STATE OF NORTH CAROLINA
DEPARTMENT OF TRANSPORTATION

SUBJECT: **Permit Modification Request for TIP I-2511CB**, I-85 Improvements from North of SR 1002 to North of SR 2120 Near the Town of Spencer in Rowan County, State Project No. 8.1631503, Tip No. I-2511CB.

Site 1, Sheet 4 of 35

PROJECT: 81631503 (1-251CB)
I-85 FROM NORTH OF SR 1002 (BRINGLE
FERRY RD.) TO NORTH OF SR 2120
(LONG FERRY RD.) NEAR SPENCER
SHEET 4 OF 35
REVISED 10/22/07

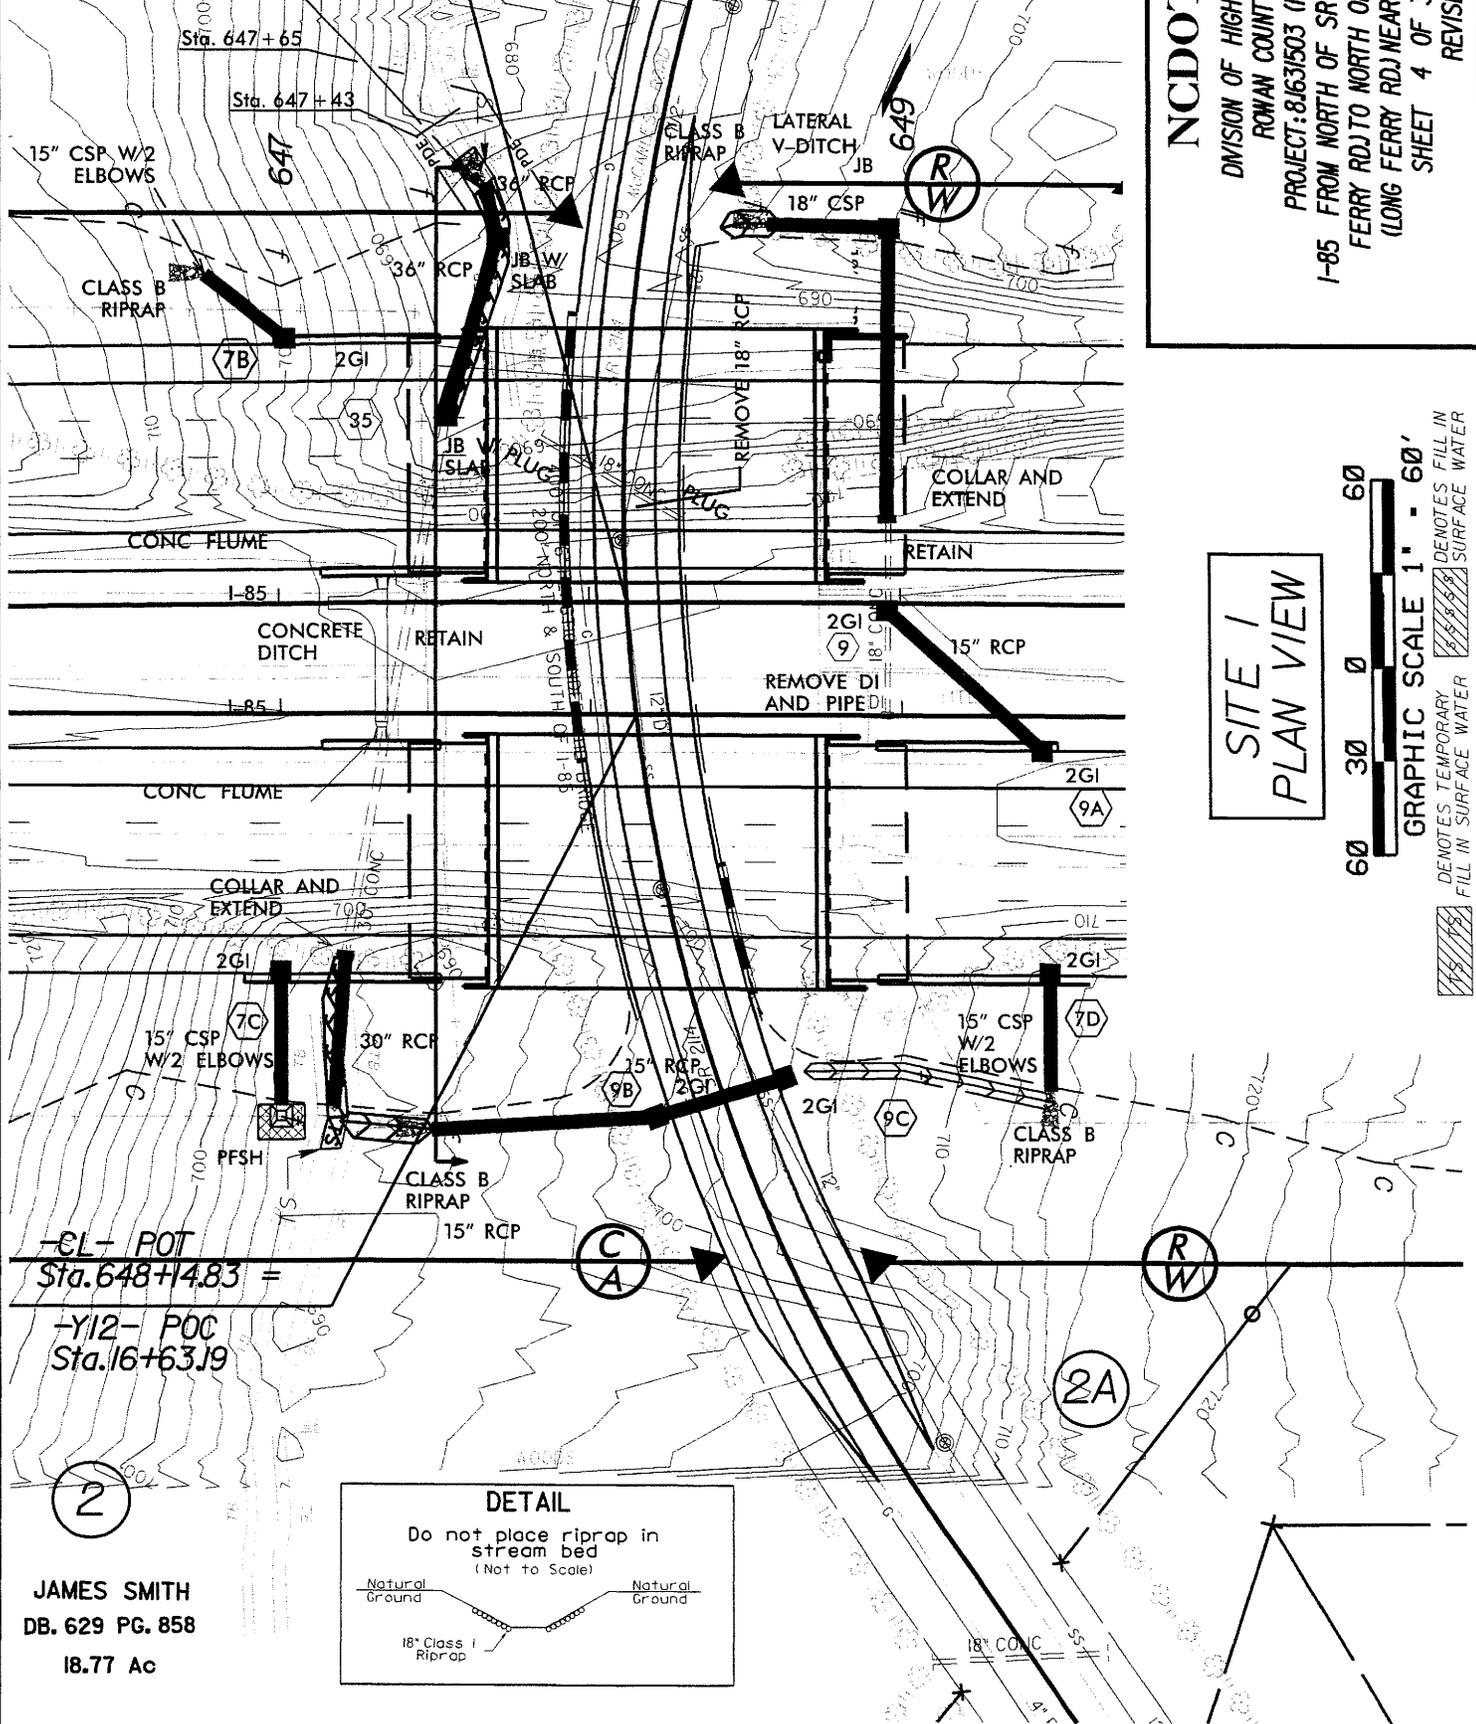
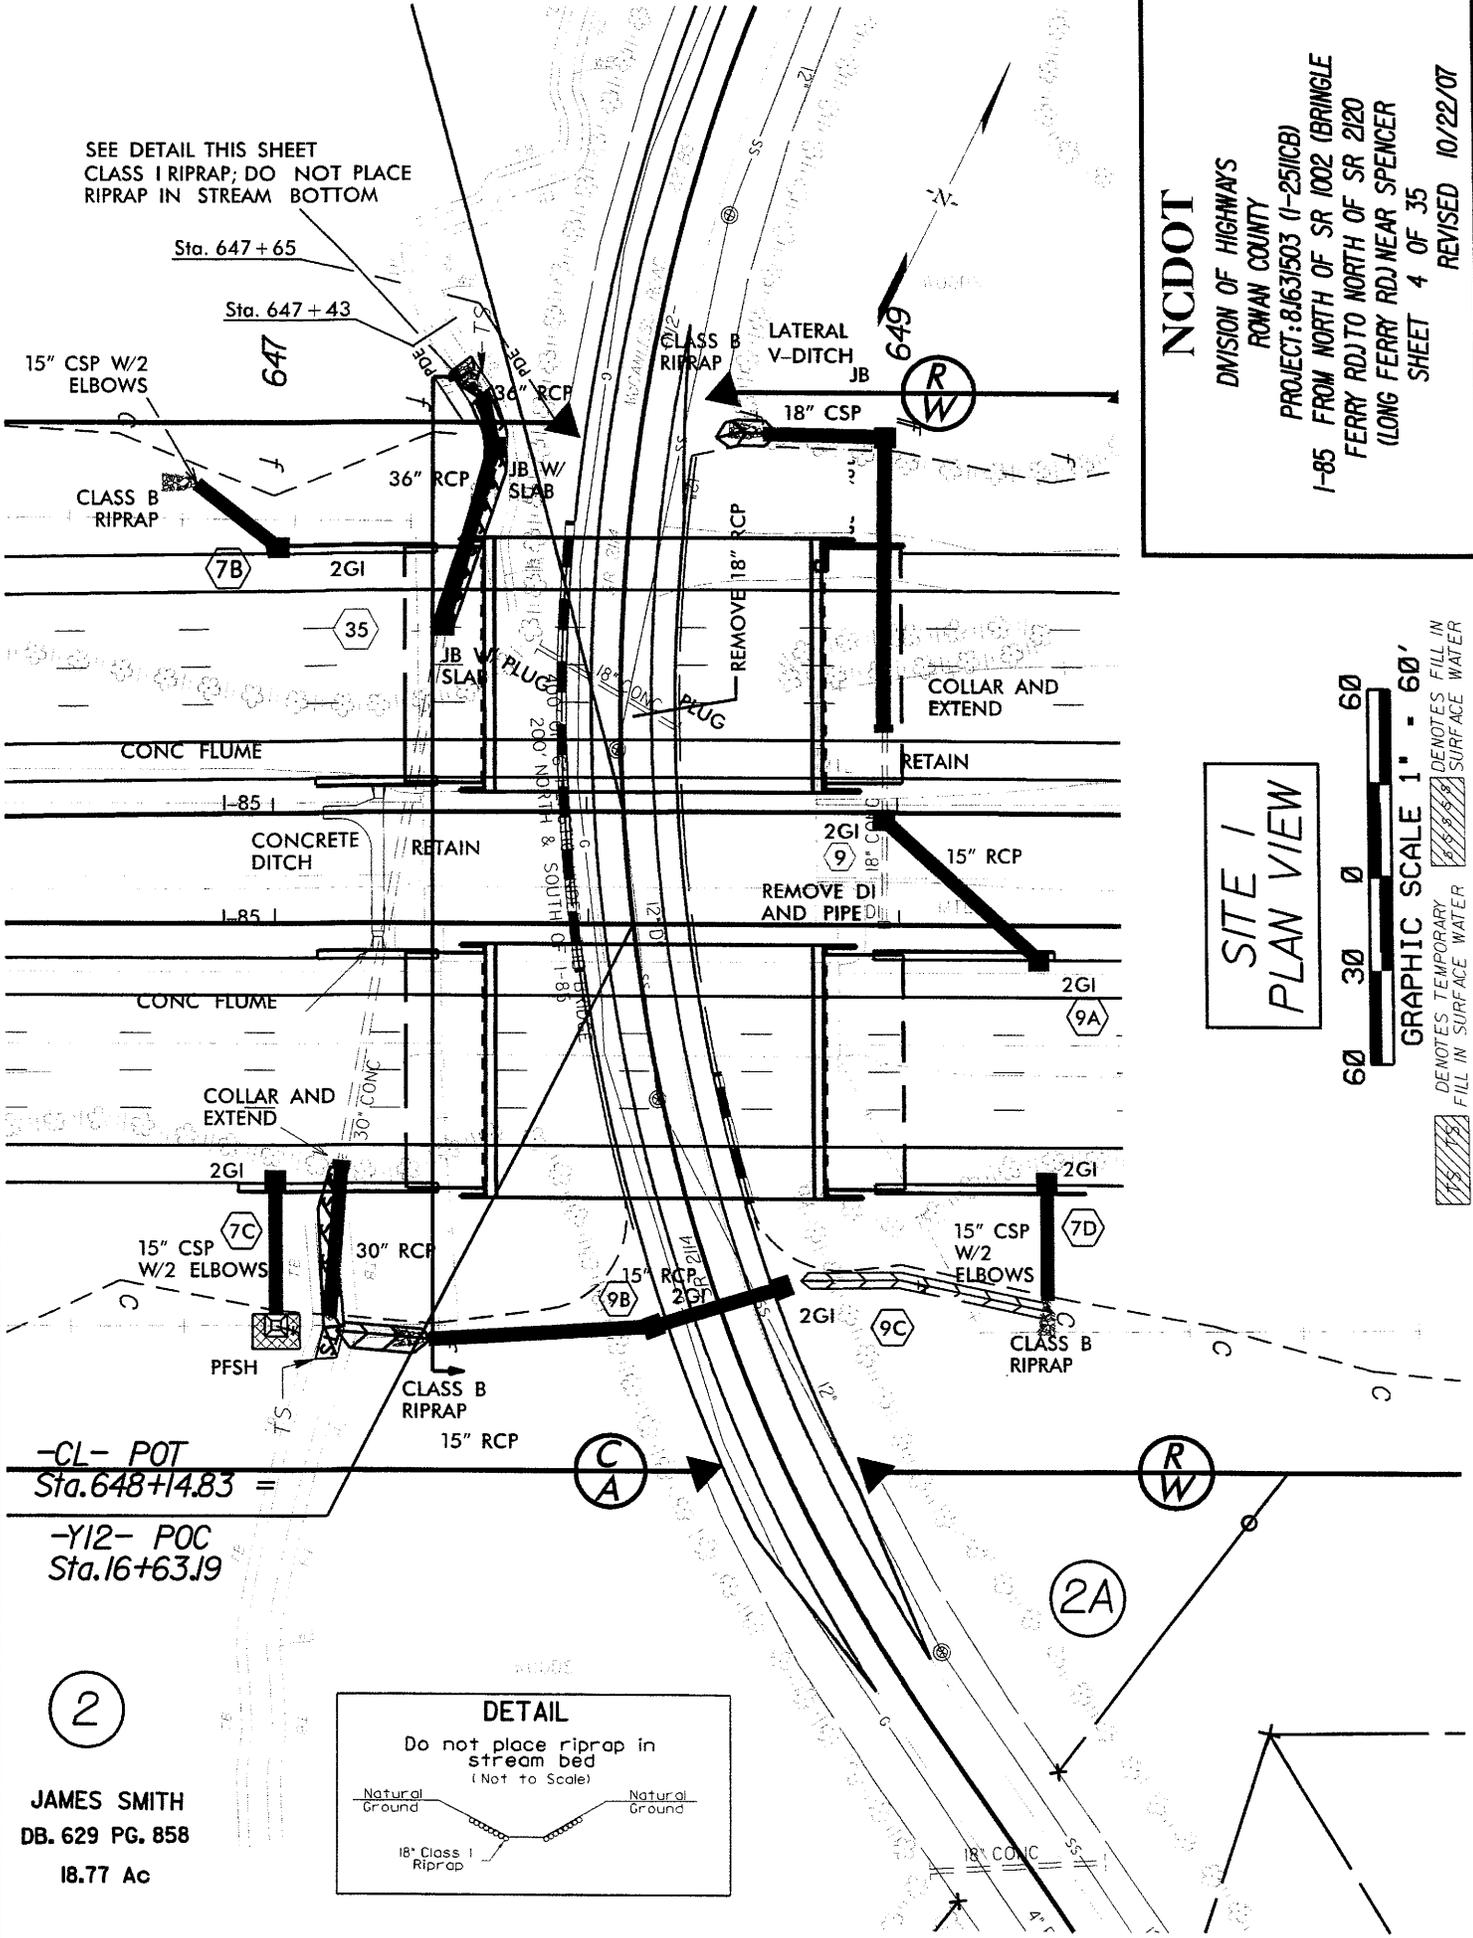
Station 647+50 – L – (LT/RT)

The design for the existing RCP extension in UT to Town Creek is being proposed for modification to eliminate the headwall previously permitted due to the amount of blasting of bedrock in the stream channel that would be required to construct the footing for the headwall. The additional 13 linear feet of permanent stream impact is from the proposed extension of the RCP. The quantity of temporary stream impacts associated with the installation of the pipe extension is less than was associated with the headwall, although the reportable quantity (<0.01 acre) remains unchanged. The area of temporary impact will be shifted 13 feet further downstream to the end of the proposed RCP extension.

Authorized Impact: 102 linear feet permanent stream and <0.01 acre of temporary stream impacts;

Proposed Impact: 115 linear feet permanent stream and <0.01 acre of temporary stream impacts.

Impact change: increase of 13 linear feet of permanent stream impacts (which requires mitigation through EEP).

SEE DETAIL THIS SHEET
CLASS 1 RIPRAP; DO NOT PLACE
RIPRAP IN STREAM BOTTOM
